# Site Accessibility Evaluation

**Woodmen Park & Ride  
PU18-0089**

**6995 Mark Dabling Blvd  
Northeast Colorado  
Springs, CO 80919**

SUBJECT: Woodmen Park & Ride Self-Evaluation

Image of narrow access aisles

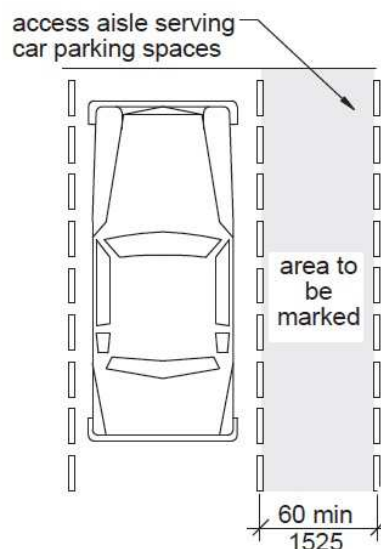
The access aisles are not a minimum 5 feet wide. One of the access aisles is 4'-6" wide, and one is 4'-3" wide. However, there is an extra access aisle at the end of the accessible parking.

There are two access aisles that are too narrow.

Restripe the accessible parking and access aisles, reducing the width of the extra access aisle, and adding width to the two narrow access aisles.

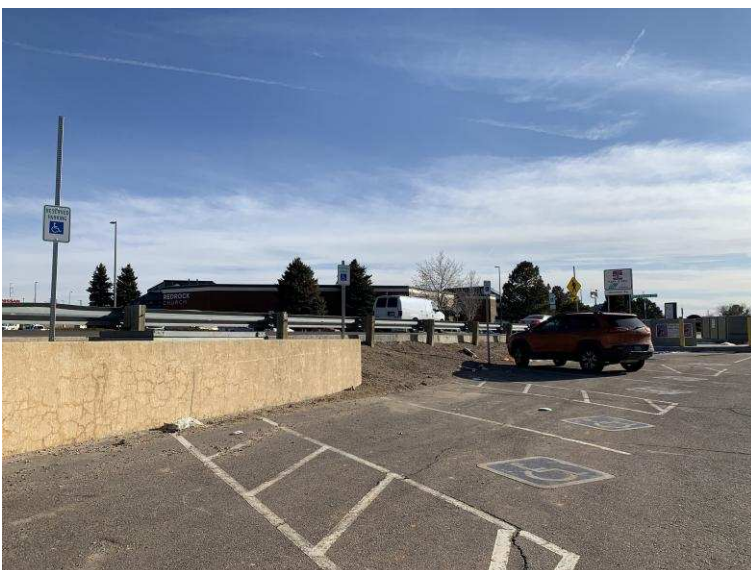
The accessible parking signage is mounted higher than 7'-0" to the bottom of the lowest sign.

The signage on the left parking space is mounted at 8'-2" to the bottom of the sign.

The signage on the 2nd from left parking space is mounted at 7'-8" to the bottom of the sign.

The signage on the 3rd from left parking space is mounted at 7'-6" to the bottom of the sign.

The accessible parking signage is mounted too high.

Lower the signage to between 5'-0" and 7'-0" to the bottom of the lowest sign.

Image of sidewalk with vertical displacement

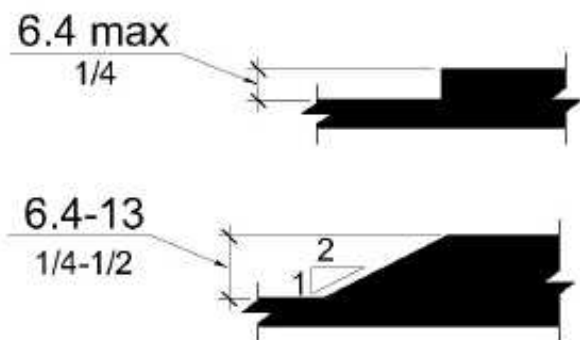
The surface of the pedestrian access route has vertical discontinuities greater than 1/2 inch or between 1/4 inch and 1/2 inch that are not beveled.

There are two areas of 1" vertical displacement on the bridge.

Grind to less than 1/2".
